**ADDENDUM NO. 2**  
**Woodruff Landfill: Phase 7 Expansion Construction (Rebid)**  
**Transylvania County, North Carolina**

SUBJECT: ADDENDUM NO. 2 dated March 27, 2025, to the Contract Documents for the Woodruff Landfill – Phase 7 Expansion Construction (Rebid), dated February 21, 2025.

# CP-09

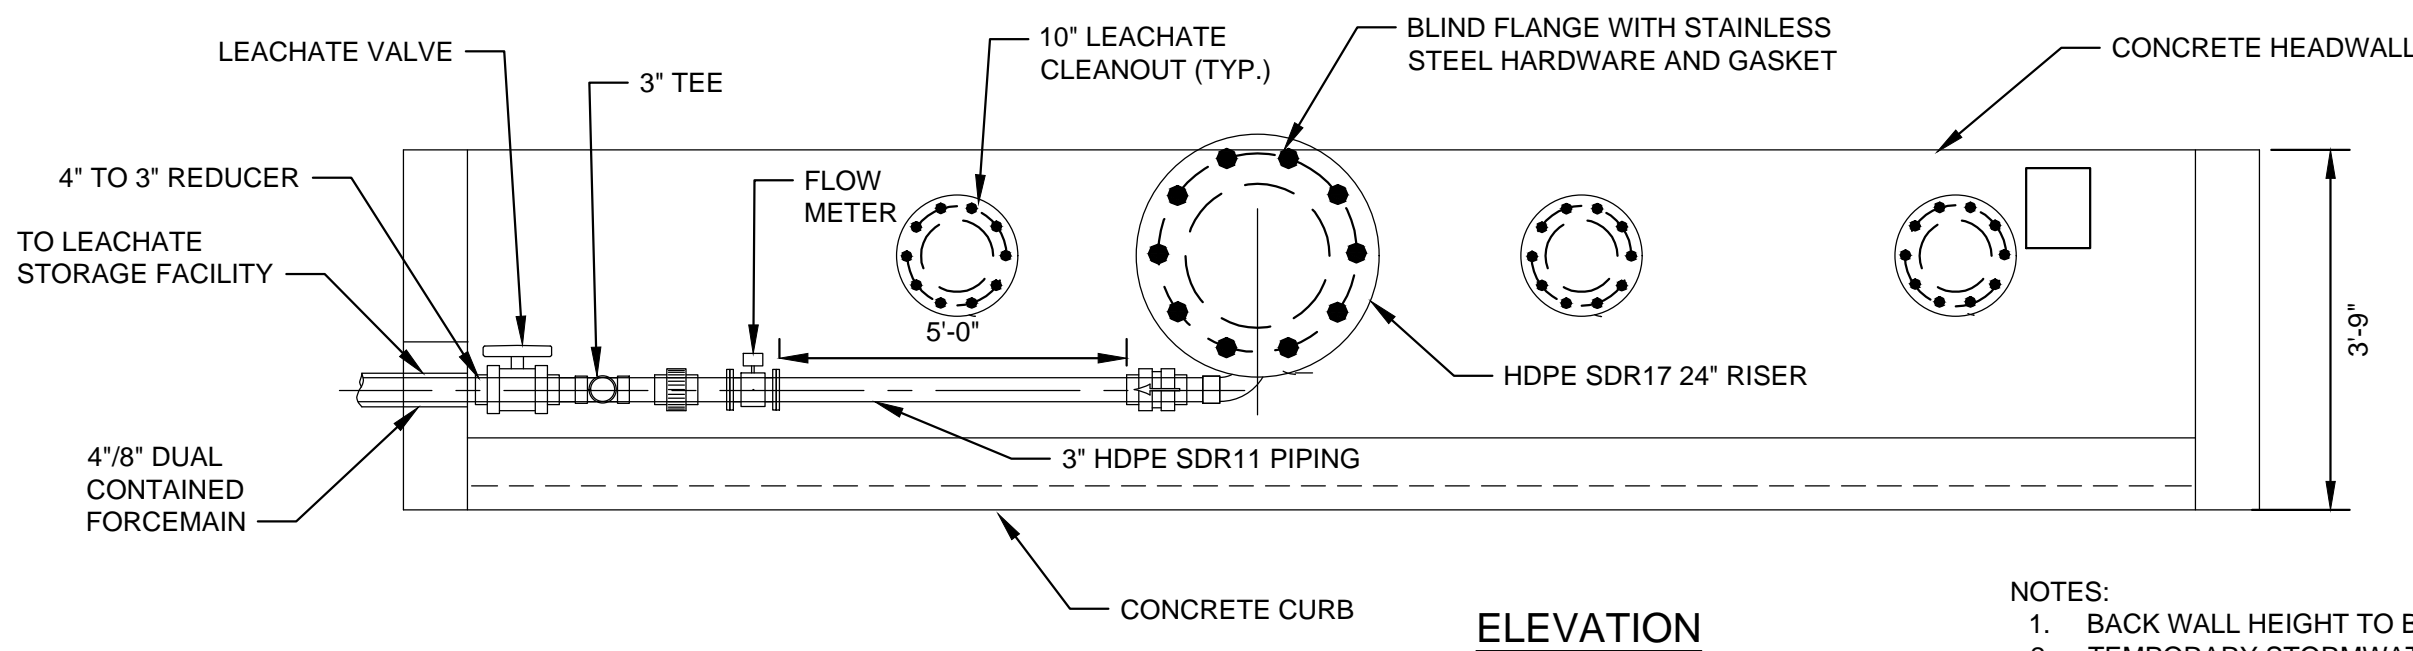
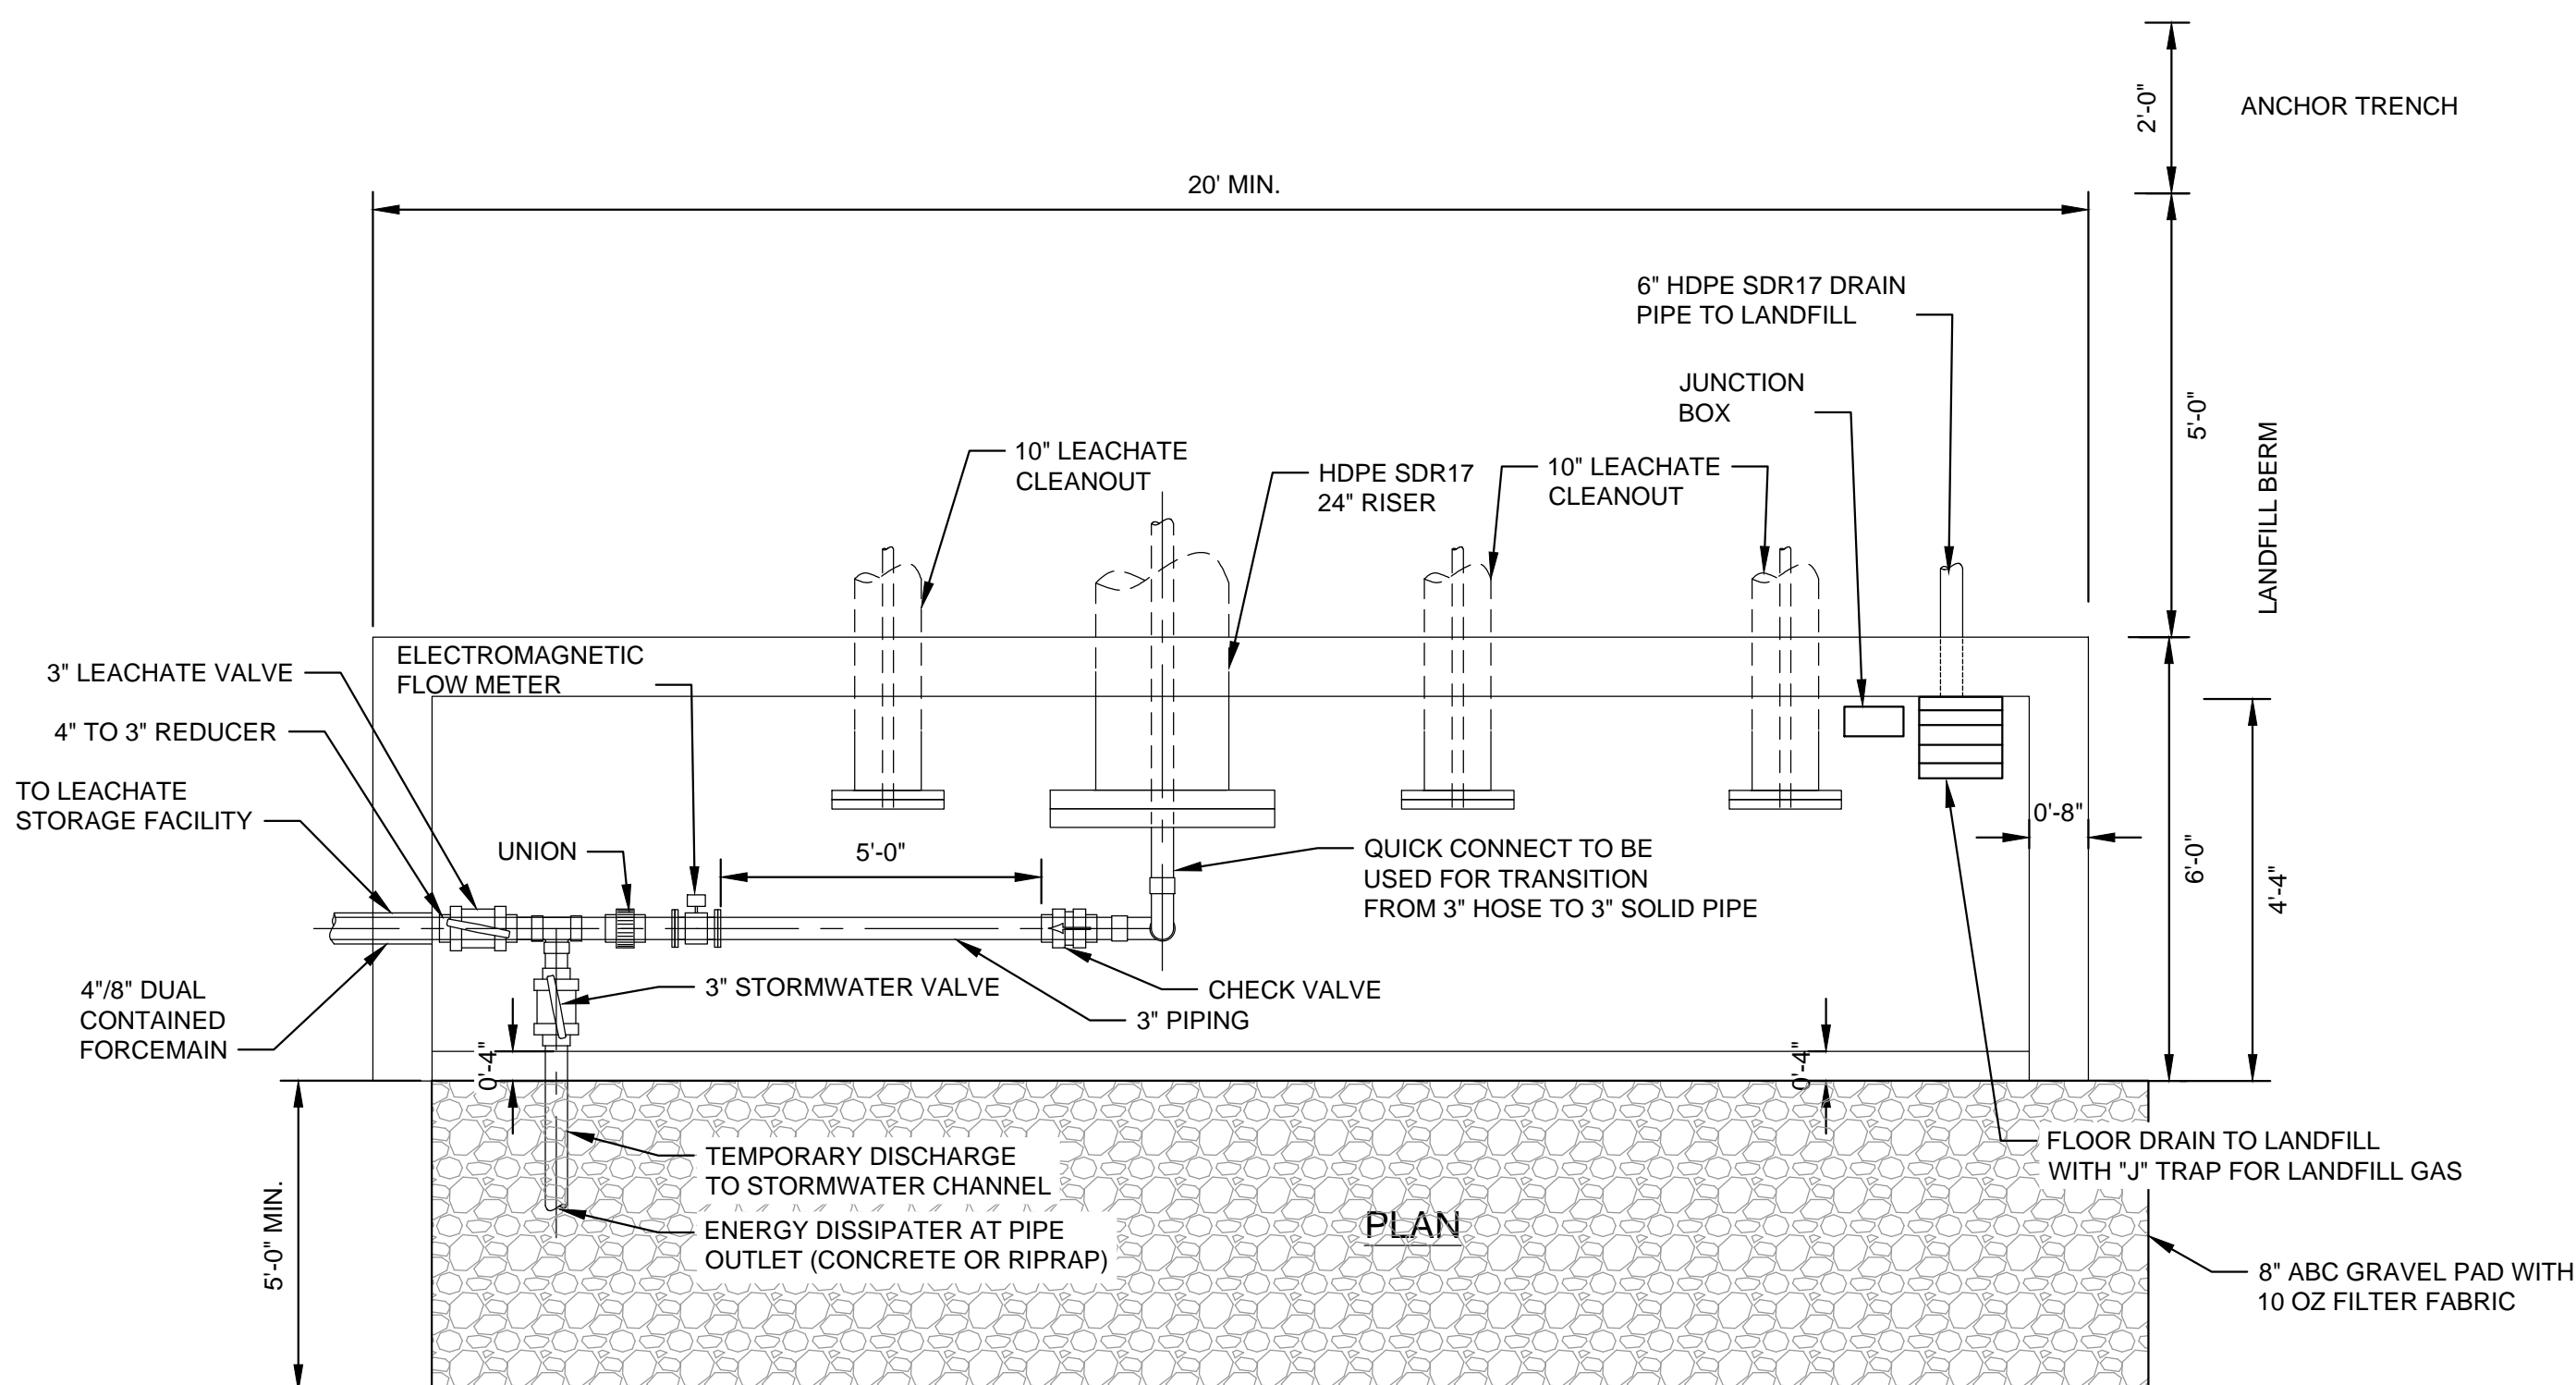
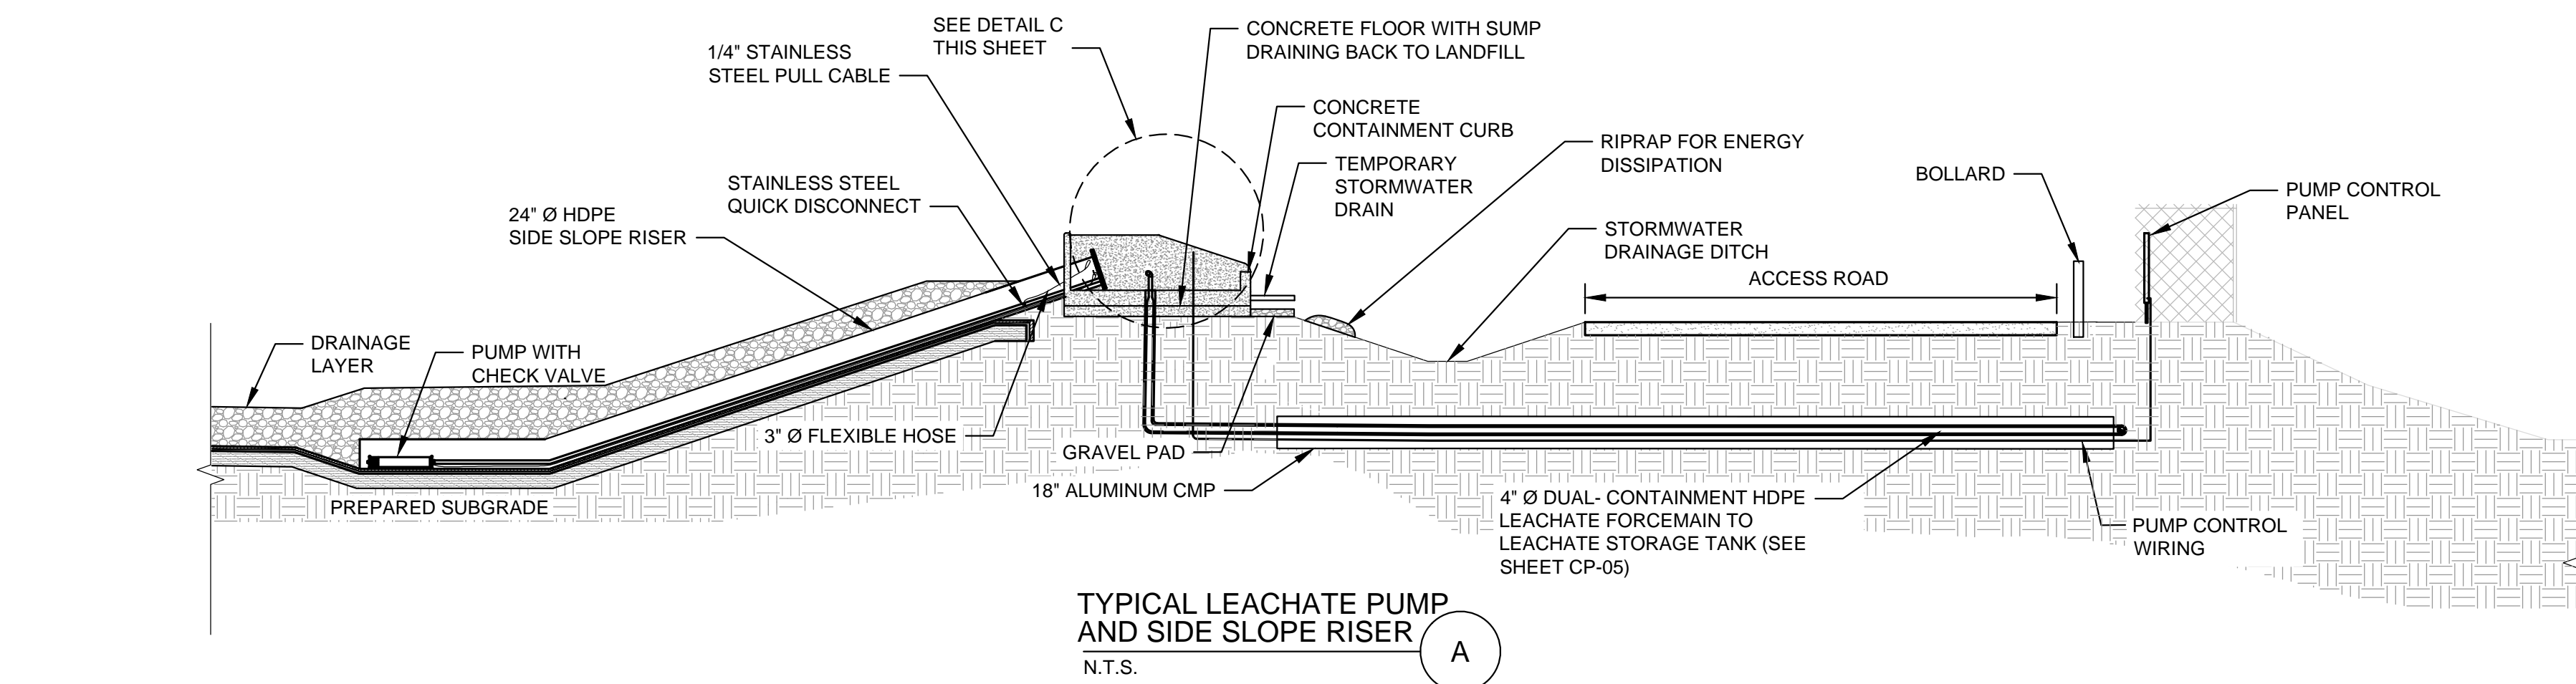
- Q.24 Will the Side slope Riser be 18" or 24"? There are two different details showing different sizes on Sheet CP-09.
- A.24 The side slope riser (SSR) is 24". Drawing Nos. CP-09 and CP-10 have been revised to update the SSR size.
